FORD 5R110W "Torqshift"

INTERNAL HARNESS OR SOLENOID BODY SERVICE

Figure 1

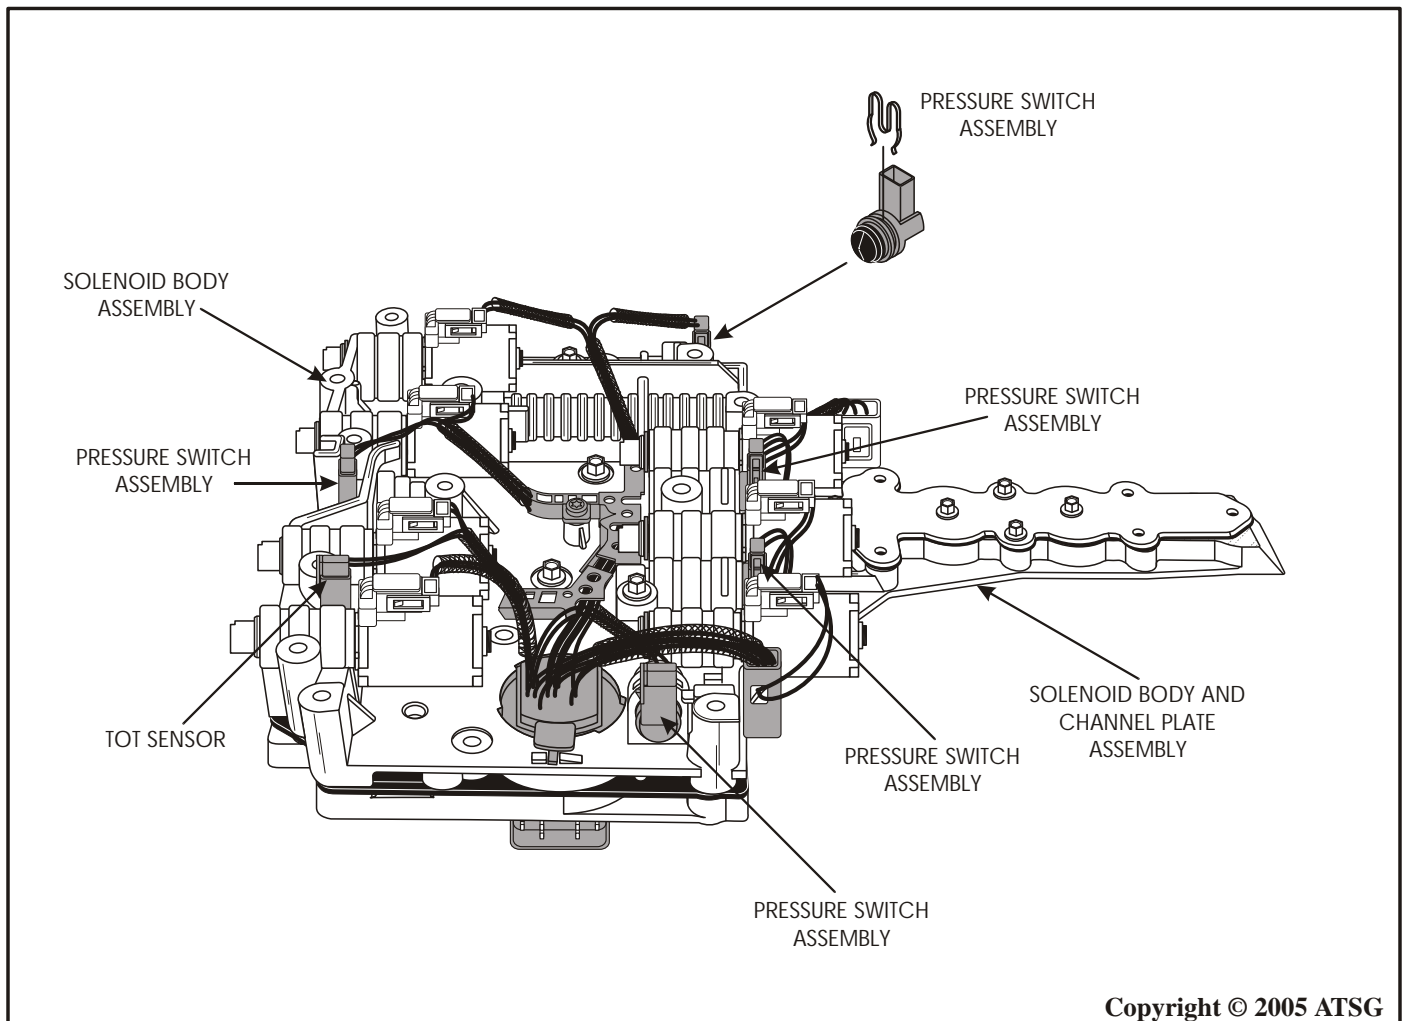
If it becomes necessary to replace the internal wire harness and/or the entire solenoid body on a 5R110W Torqshift transmission, please be aware of the following:

1. You may have to install a new service harness, without pressure switch connectors, into a unit that has pressure switches in the solenoid body. (See Figure 1 for locations)
2. You may have to install a new service solenoid body, without pressure switches, into a unit that has the original internal harness with pressure switch connectors. (See Figure 1 for locations)

Note: *These are both acceptable repairs and will not affect the function or operation of the transmission. Use of the pressure switch input was dropped from the vehicle calibration before the 2003 model year went into production.*
